**Conditions for Approval of Site Plan for Subdivision**

**SITE PLAN FOR BLDG. PERMIT SITE PLAN FOR SUBDIVISION**

**UPTOWN SPECTRUM DRB SUBMITTAL**

**RESPONSE TO CONDITIONS**

**LANDSCAPE PLAN**

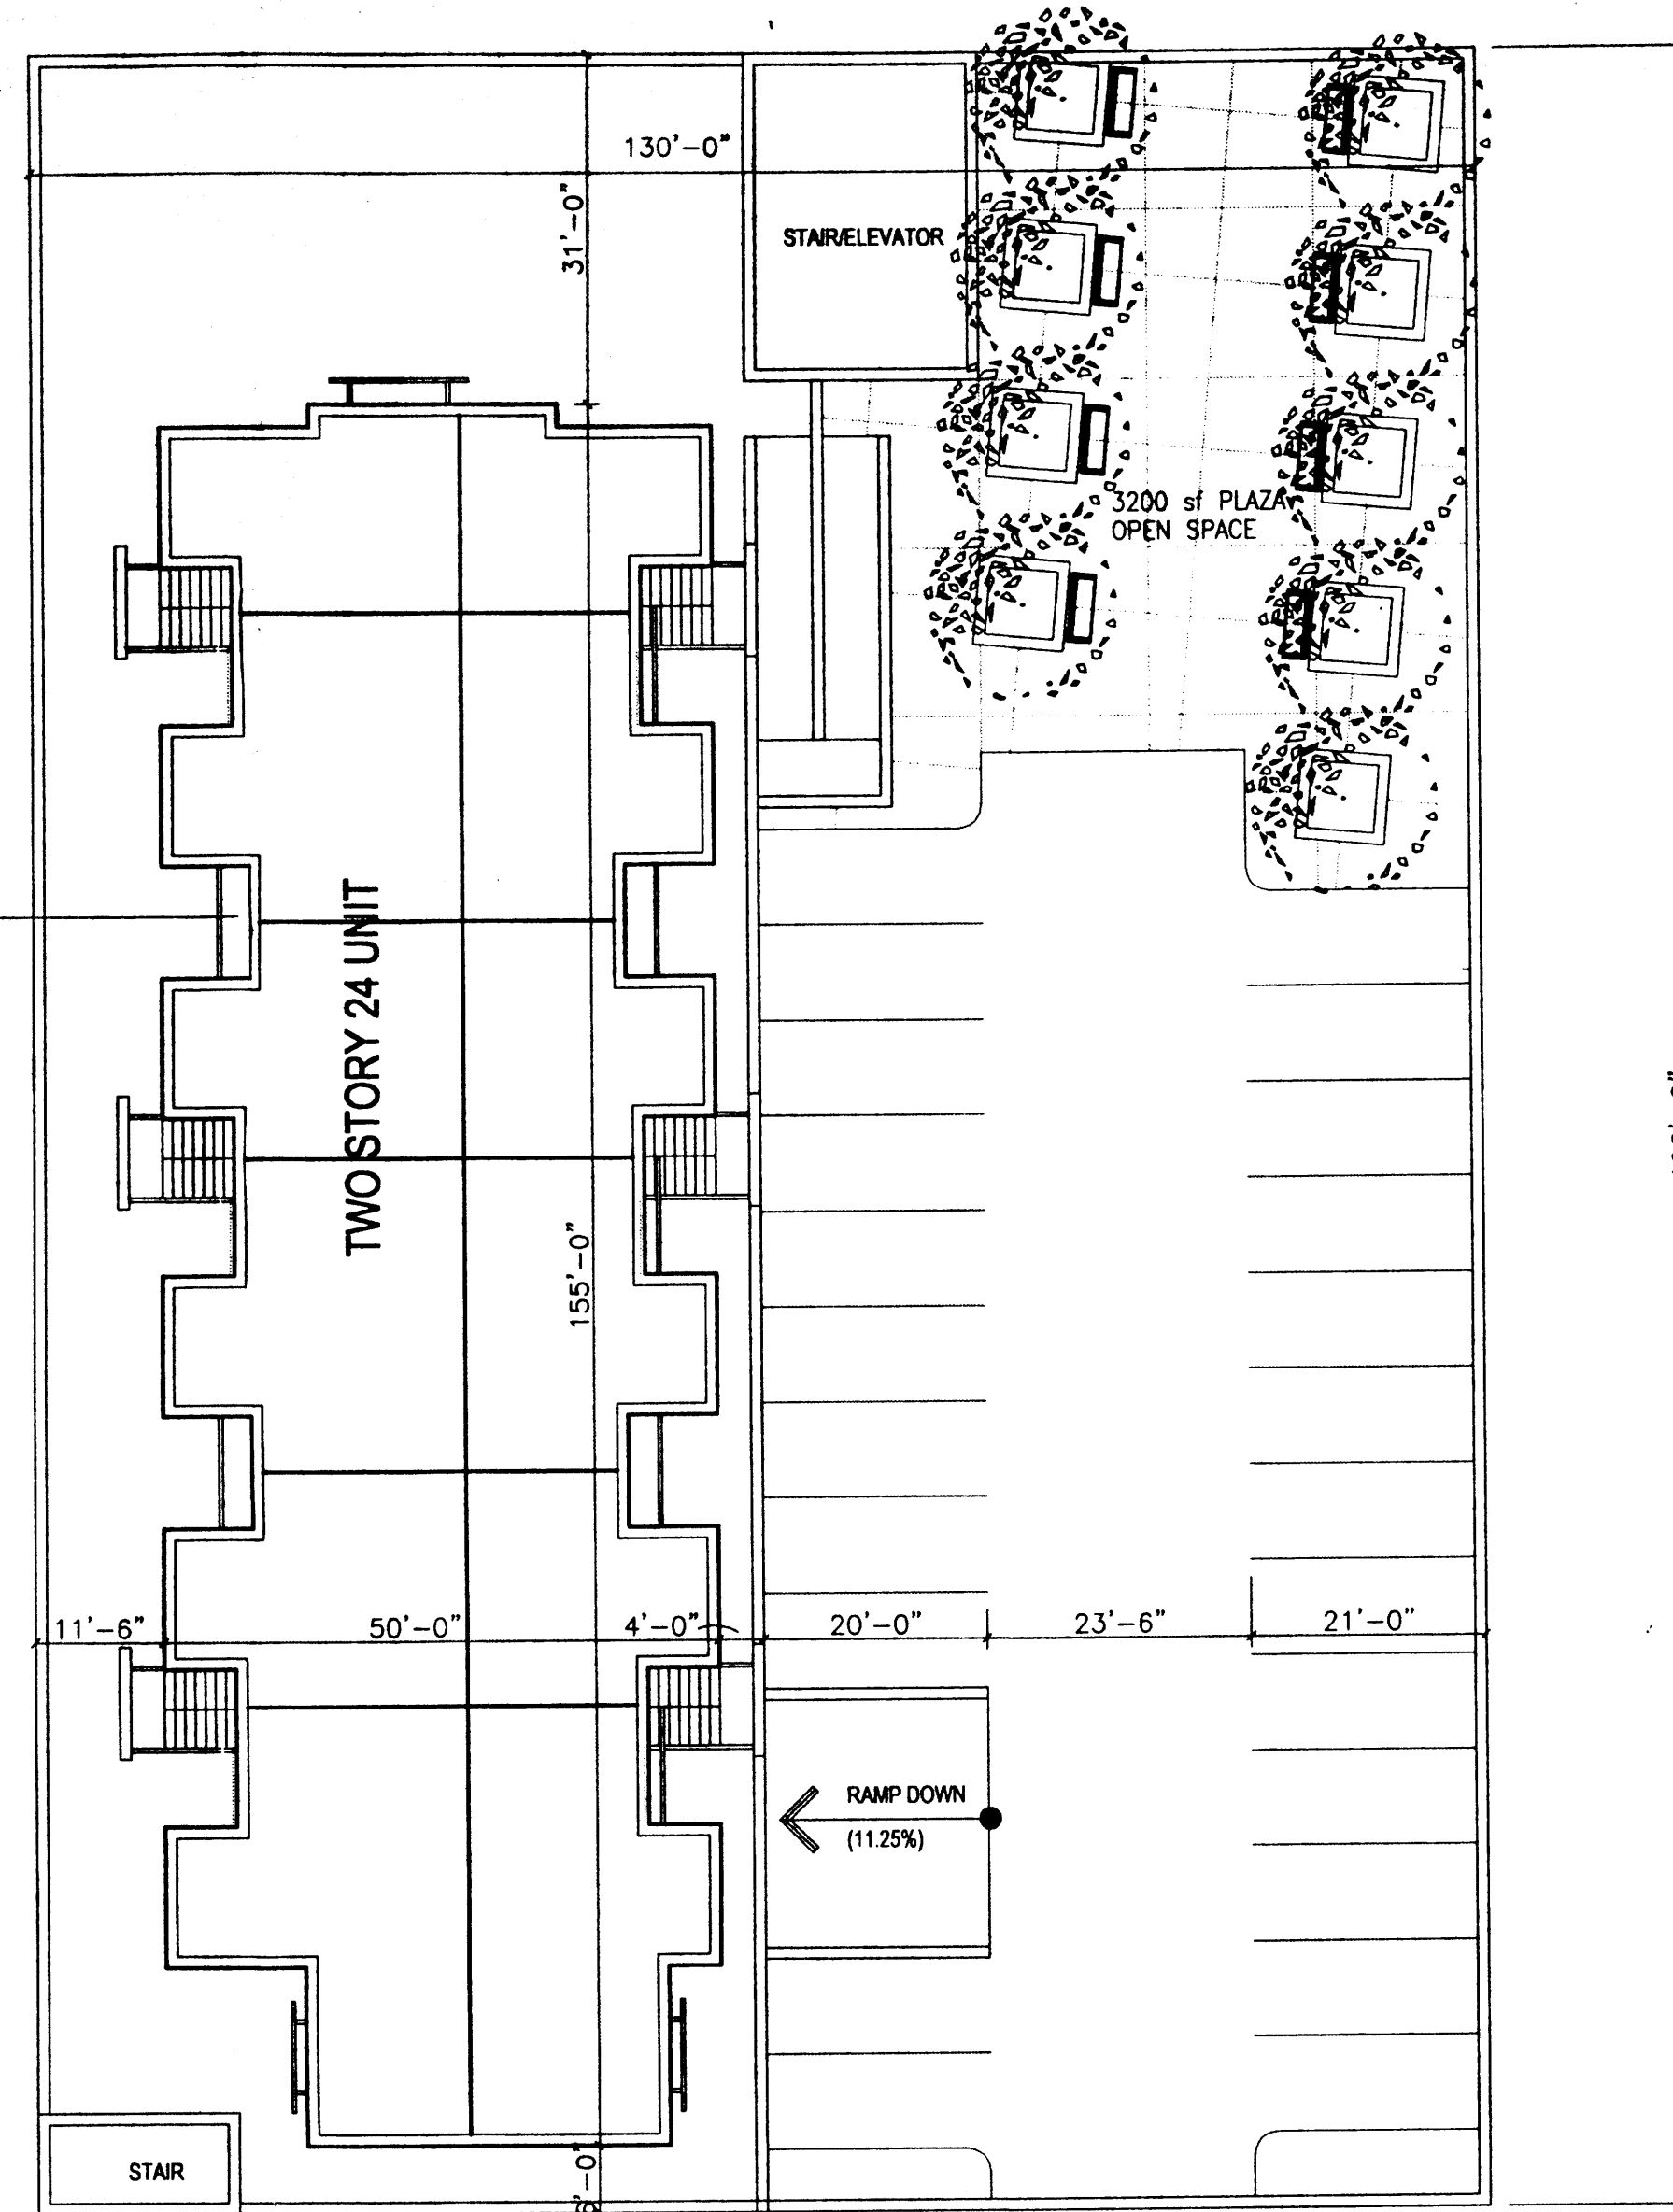
3. The applicant shall submit for DRB review a complete landscape plan, including all required vegetation elements, specifying such specific landscape details as bench placement, planter areas, tree planting hole and gate details, drainage, and irrigation. The applicant shall also provide landscape plan for all plaza areas drawn in detail at a maximum scale of 1"=10'. The plan should also locate and identify lighting, signage, public art and other elements not well illustrated in the submitted plans.

16. Street trees shall be added at 30 feet on center on the Westside of the restaurant building along Louisiana.
17. Delete the walkways shown on the east, west and south side of the parking garage number 2, convert it to landscaping.

18. Improve pedestrian connections from garage number 2 to the pedestrian ways to the east, west, and south of the site.
19. Within the sidewalk directly to the east of the south restaurant, the sidewalk runs in an east/west direction. Shade trees shall be added at 25 feet on center along the pedestrian way.

- 3 The Landscape Plan consists of three sheets - one 40-scale site plan and two sheets of 10-scale Plaza enlargement plans. Locations for site furnishings, including benches, waste receptacles, portable planters, tree guards and art, are illustrated on the landscape plans. Plant materials are illustrated on the plans and keyed to plant schedules located on each Landscape sheet.

- 3 Planting and irrigation installation details shall be per City of Albuquerque standards.
- 7 Additional landscaping has been added at several locations around the site. Portable plantings have been added at an entrance to the north-south pedestrian walkway east of Retail 1. A fountain is now illustrated in the center of the pedestrian mall between retail buildings 1, 2, 3 and 5.

- 16 Street trees at 30' o.c. have been added to the west side of the restaurant building located on Louisiana.
- 17 The walkways on the east, south and west of Garage 2 have been converted to landscaping.

- 19 The east-west sidewalk on the north side of the restaurant has been widened. At grade planters and shade trees at approximately 25 feet o.c. have also been added to the plan.

1 Housing over Garage - Site Plan  
Scale: 1/16" = 1'-0"

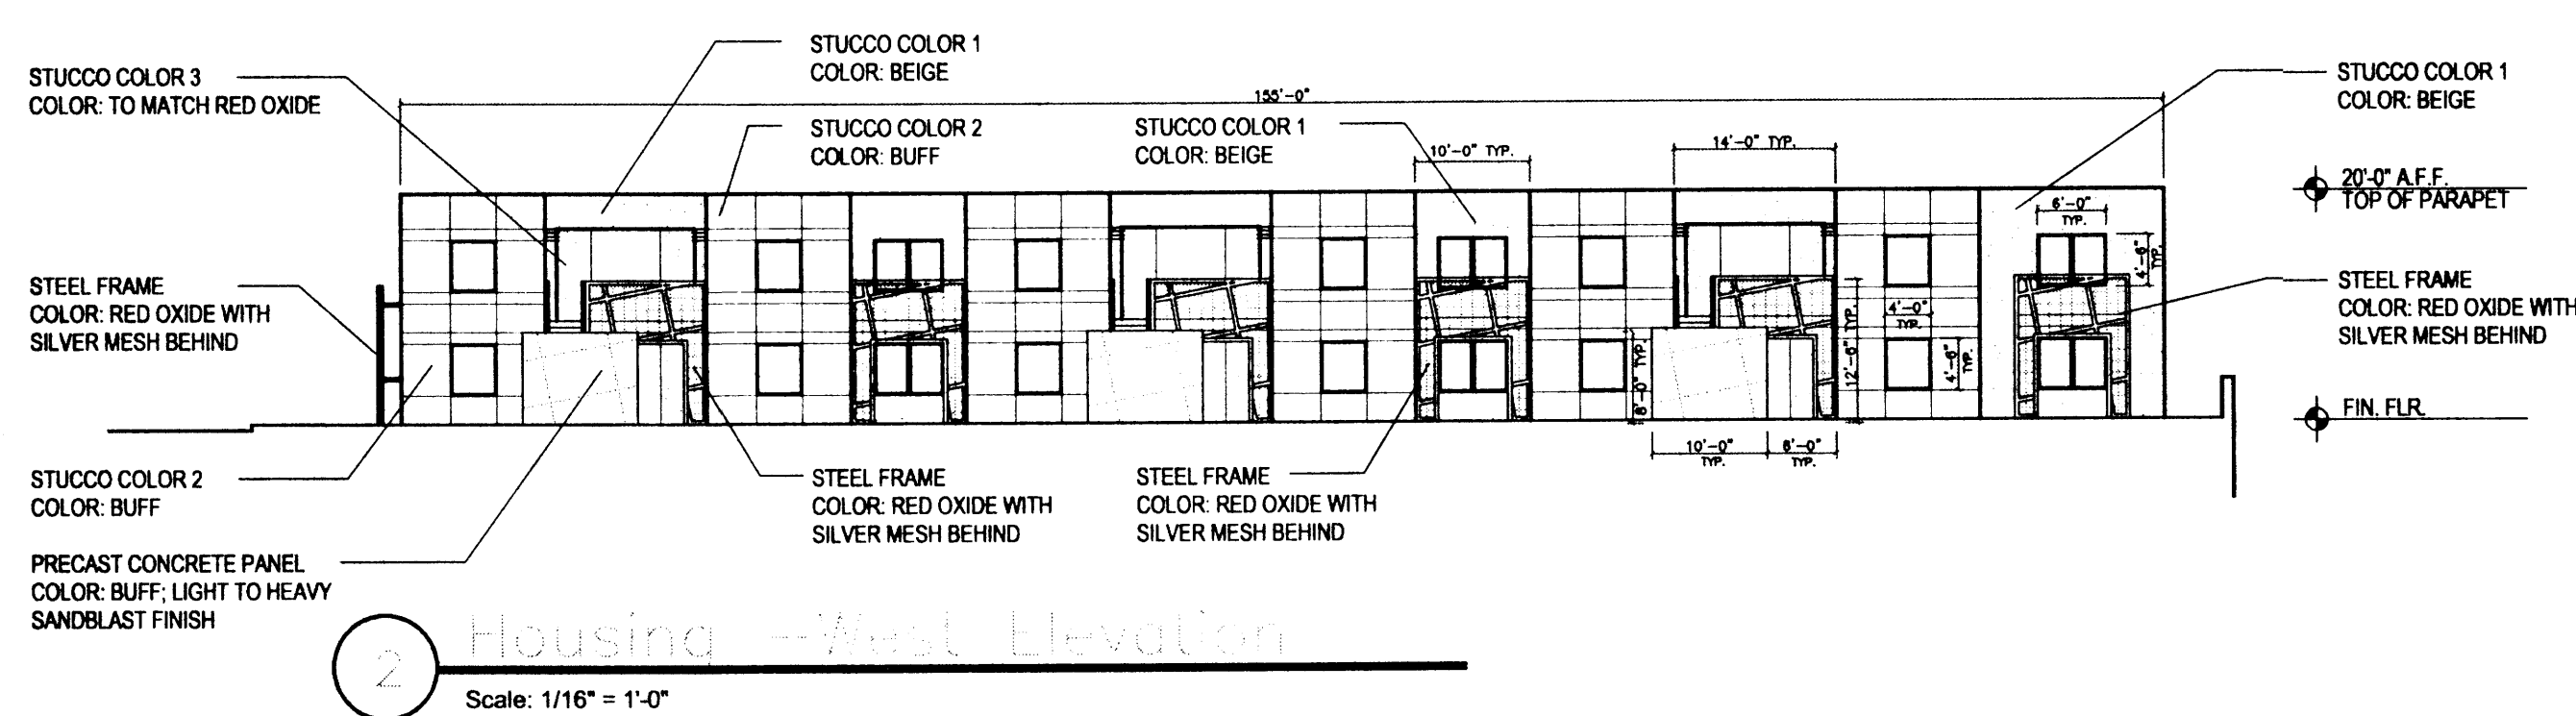
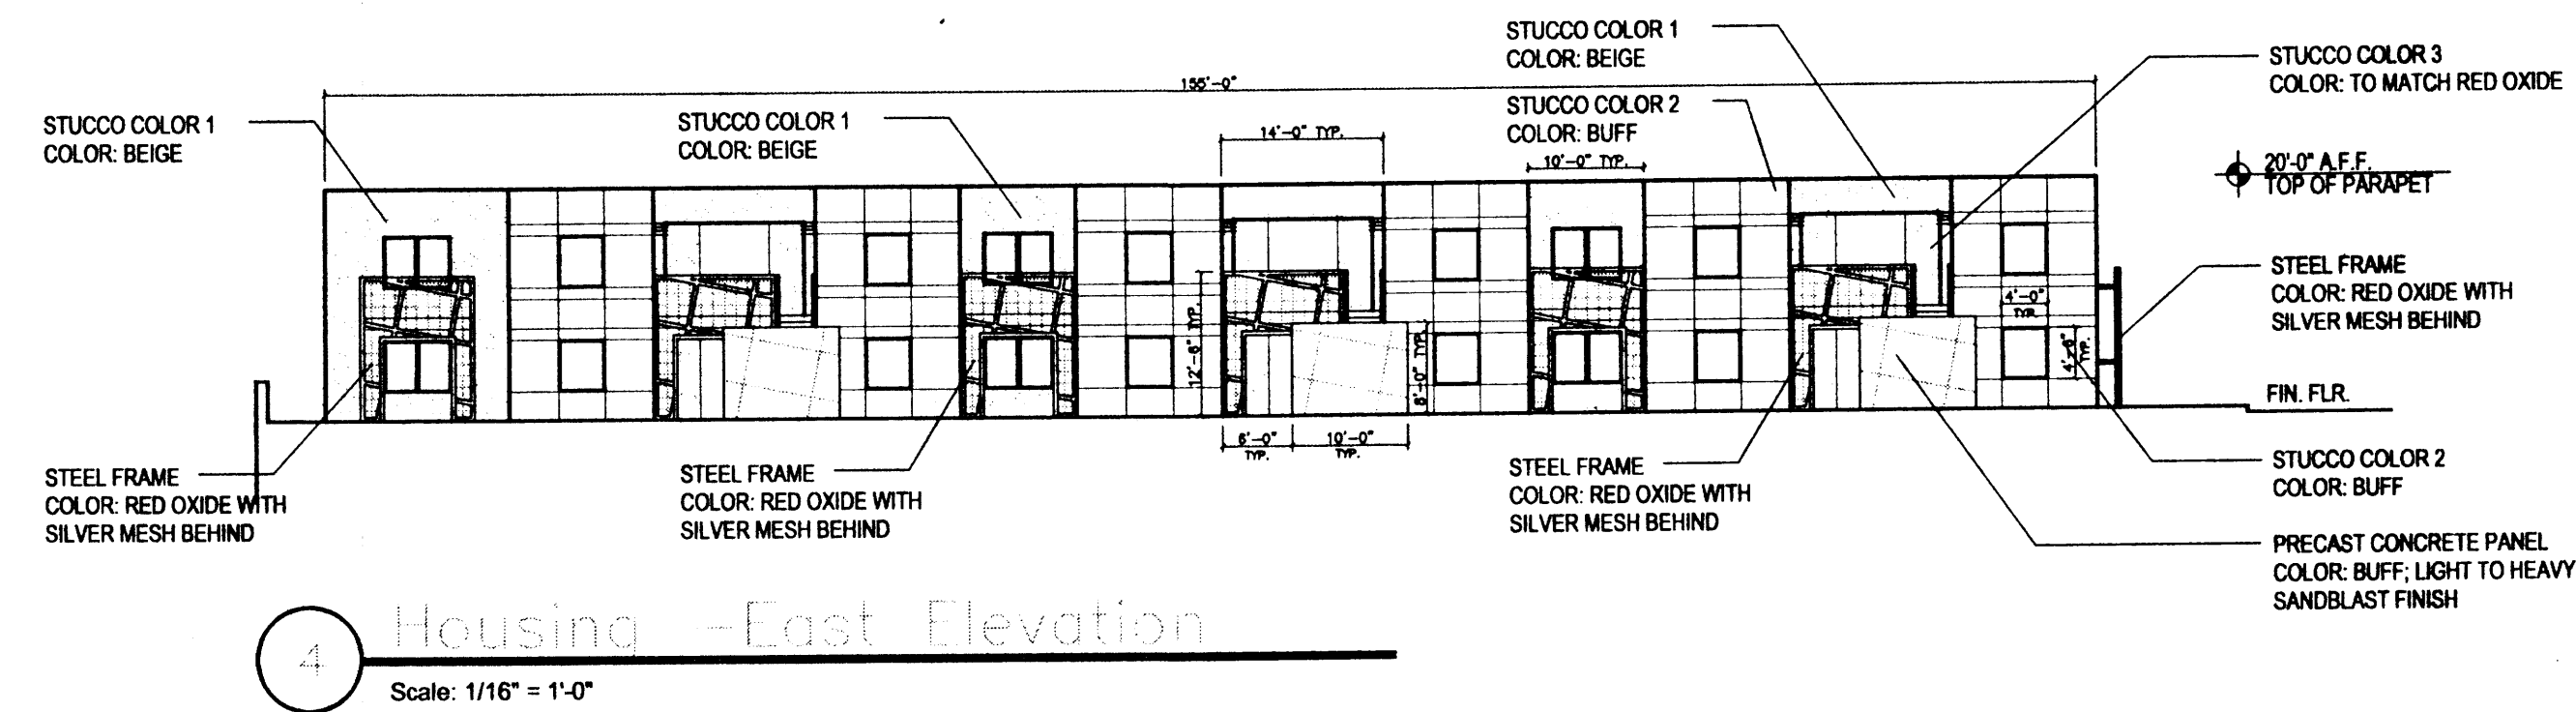
21. Each housing unit shall have a minimum of 80 square feet of open space adjacent to the unit in form of decks, terraces, or patios and a maximum of 1 parking space per unit. The revised site plan shall be submitted to the EPC site plan review committee for final approval prior to DRB submittal.

80 SF OUTSIDE  
DECK/PATIO (1 PER UNIT)
